Diamond
AIRCRAFT

Service Bulletin No.: DA20-27-05, Rev. 0

Title: Rudder Support Bracket Inspection

Figure 1.

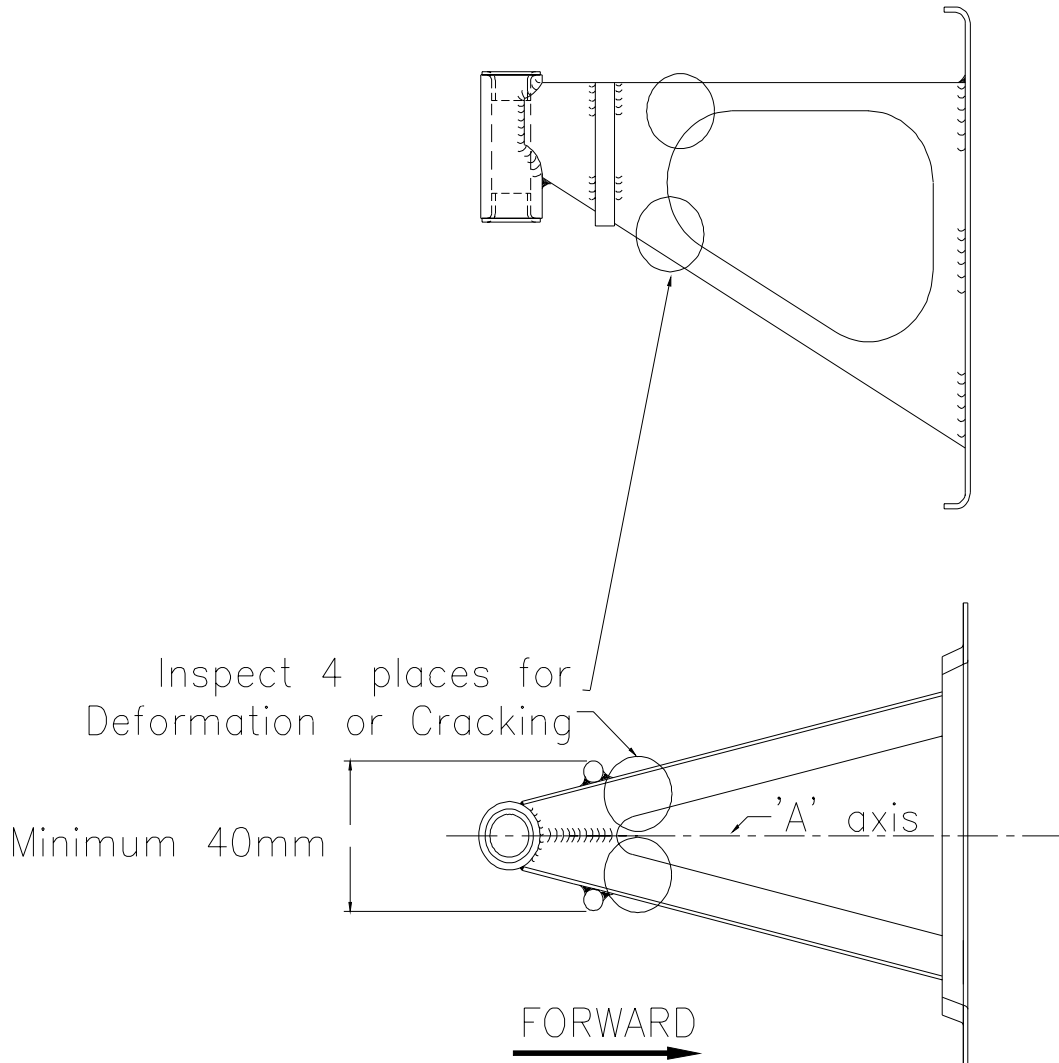
- 10.1.1 Remove control lock if installed.
- 10.1.2 Use a flashlight and suitable inspection mirror to examine the entire 'Rudder Support Bracket' for damage, paying particular attention to the area around the rudder stops as shown in figure 1.
- 10.1.3 If no damage is present install the control lock.

- 10.1.4** If damage of any form is noted remove the rudder and check that the deformation of the rudder tower is within the following specified limits.
- a.) Check that the rudder tower has remained symmetrical along the 'A' axis as depicted in figure 1.
 - b.) Check that the dimension between the rudder stops is **not** less than 40mm.
 - c.) Check that there is no visible cracking of the metal.
- 10.1.5** If the Rudder Support Bracket is within the above limits but shows signs of deformation the aircraft may be operated for a period up to the next 100 hour inspection with 20 hour intermediate inspections after which time the part may be replaced at the operator's convenience.
- 10.1.6** If the deformation of the Rudder Support Bracket exceeds the limits described in 10.1.4 a,b or c replace it in accordance with 10.2 before further flight.

Figure 2

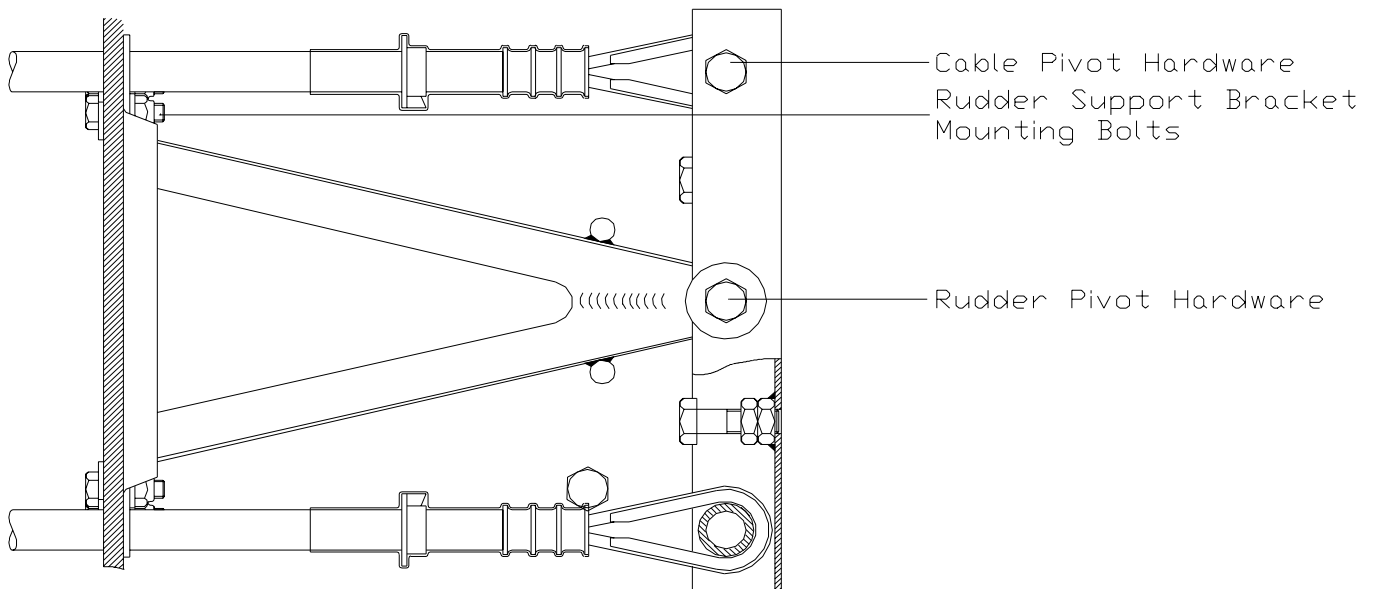
- 10.2.1** Remove the cable pivot hardware (see figure 2) from the lower rudder mounting plate. Discard the MS21044N4 nuts.
- 10.2.2** Remove the rudder pivot hardware (see figure 2) from the lower rudder mounting plate. Discard the MS21044N4 nut.
- 10.2.3** Remove the lower and upper Trim actuator attachment pins (discard cotter pins) and position the actuator so as to gain access to the upper mounting hardware on the rudder support bracket. See Figure 3.

Figure 3

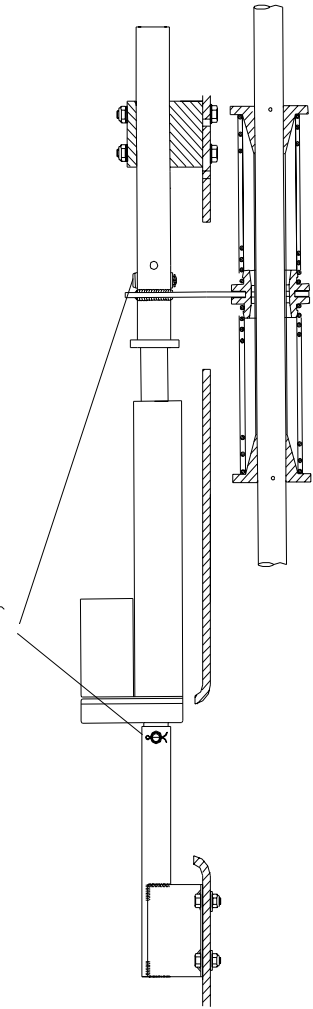
Lower and Upper Trim Actuator
Attachment Pins
